## **Historic Architectural Review Commission Staff Report for Item 9**

Application Number: H2022-0017

Address: 627 Caroline Street

After-the-fact renovations to historic residence including replacement of all siding, installation of new columns and railings on front porch, and elevation of building.

Front Elevation from Building Permit 2019-1640. Building permit plans are signed by Architect William Rowan. Annotations in red on drawings signed by Architect Carlos Rojas and provided by the contractor for this review.

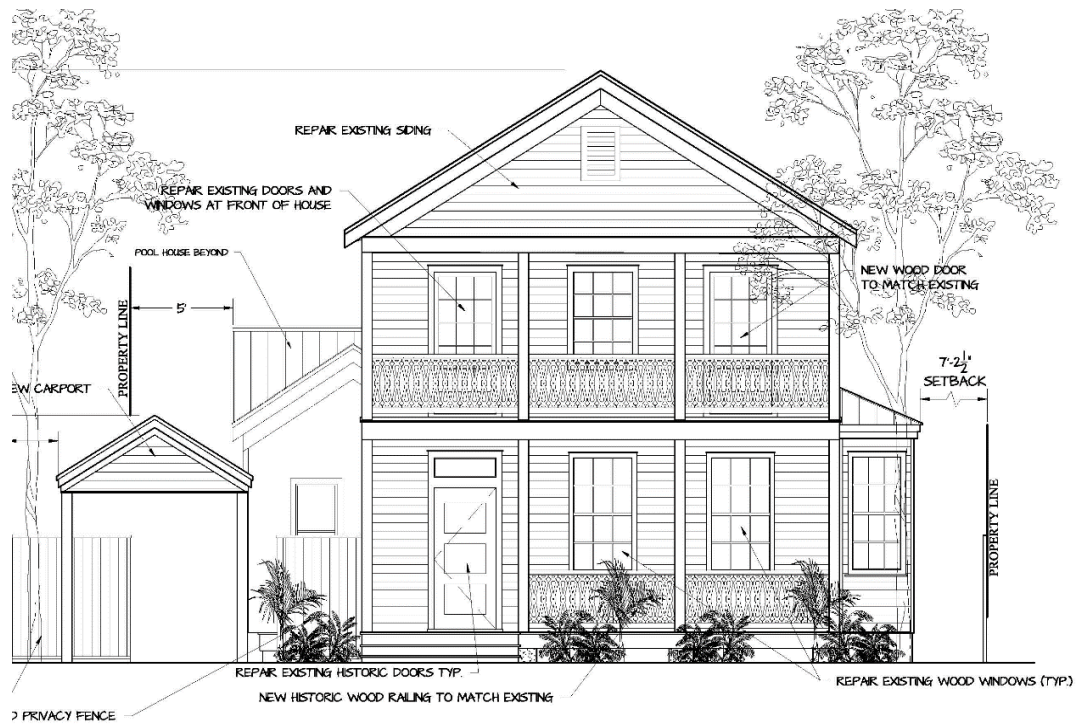
The Certificate of Appropriateness under review includes several deviations to approved plans done during construction work which consists of:

1. Change of 6" by 6" front porch columns to 8" by 8" columns with capital, trims, and bases.
2. Removal and disposal of old pine wood lap siding, when the plans included repairs and replacement when needed and replacement of all with new.
3. Removal and disposal of old gingerbread railings from second floor front porch and replacement with 44 ½" high railings. Wood turned balusters were used.
4. New gingerbread railings for first floor porch replaced with turned wood railings.
5. Higher new foundations than approved ones.
6. Dintel details on the front step's raisers.
7. Carport was built closer to the house.

It is staff's opinion that we cannot approve a final inspection for this project as the contractor deviated from what was approved by this Commission and by staff through the permitting process. Moreover, what was built is inappropriate and inconsistent with cited guidelines and the Secretary of the Interior's Standards for Rehabilitation. Removal of historic materials and departing from approved plans without approved revisions is against the principles and regulations that HARC is responsible for. The historic character of the house has been compromised by adding conjectural elements, by changing the proportions and scale of the front porch and destroying architectural features and fabric that once were part of the house.

PROPOSED ELEVATIONS

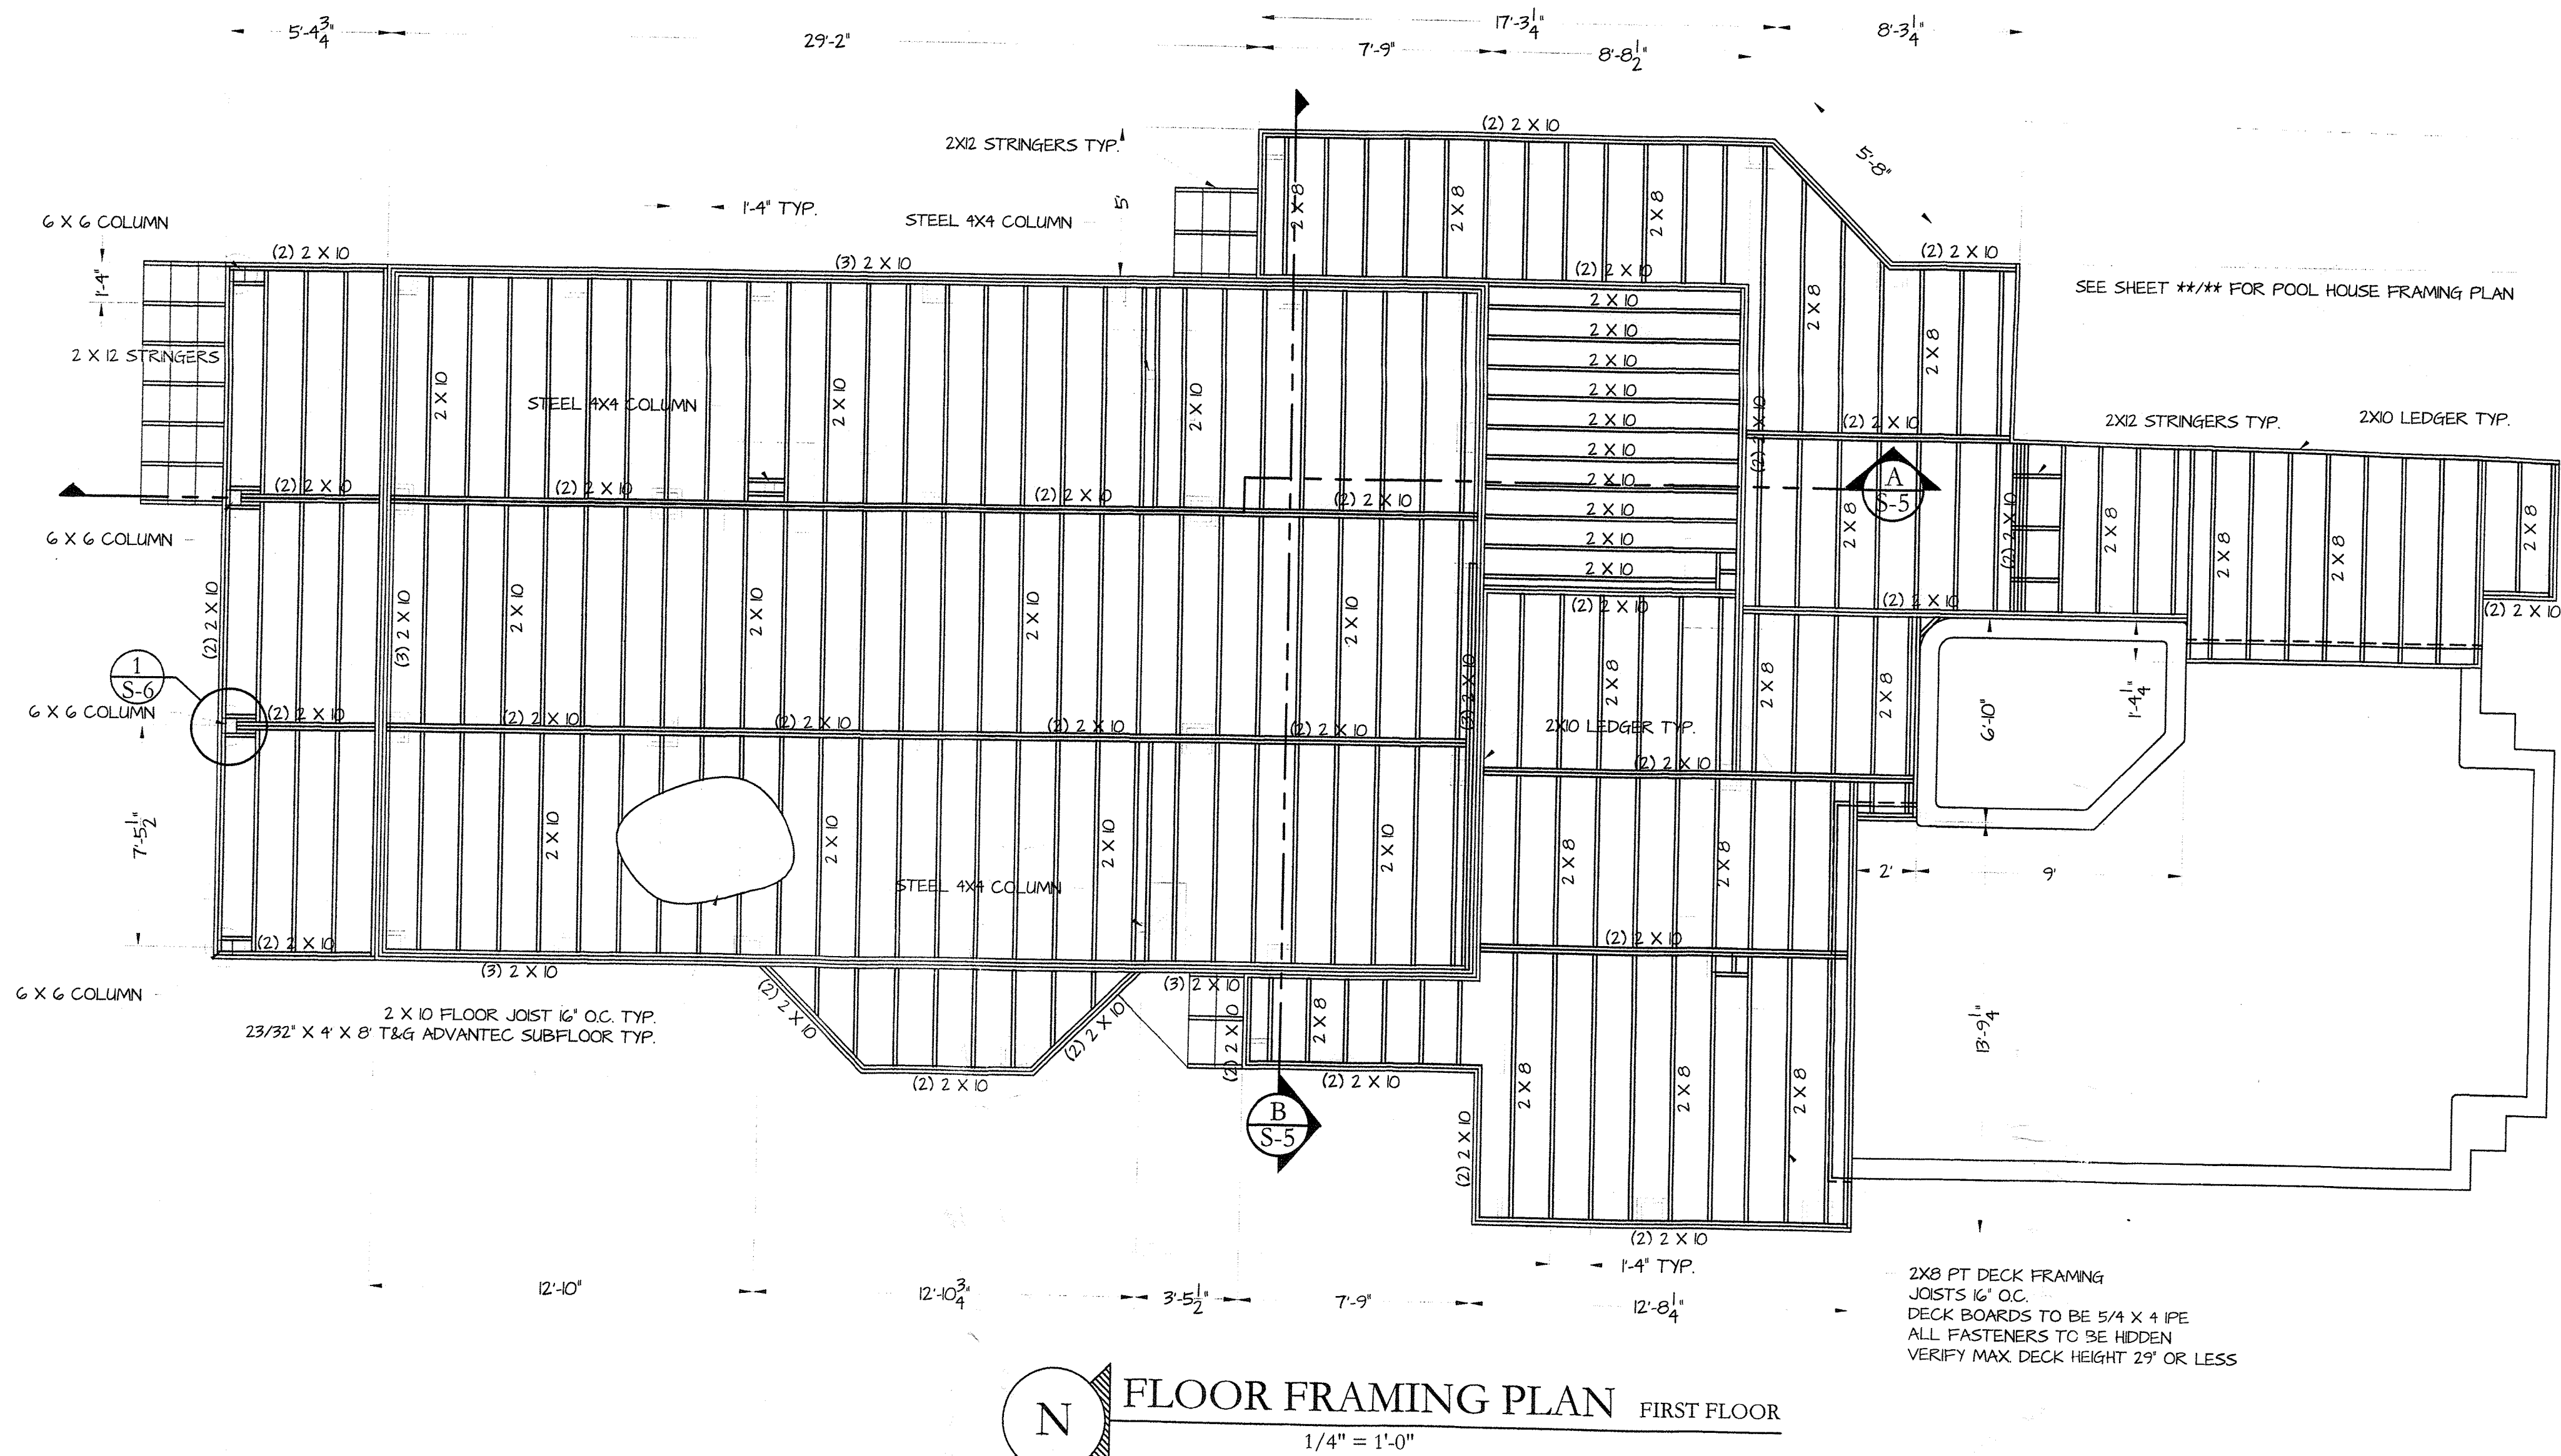
The railing has been changed from an unauthentic gingerbread pattern to a correct round spindle design that is similar to matching buildings all around it. This is more historically accurate and by necessity meets the current code for railings.

Column bases and some trim work were added to the columns. The columns now have proper capitals and a recess panel, more in keeping with the upscale nature of the historic house. These details are also found in surrounding structures of similar age and design.
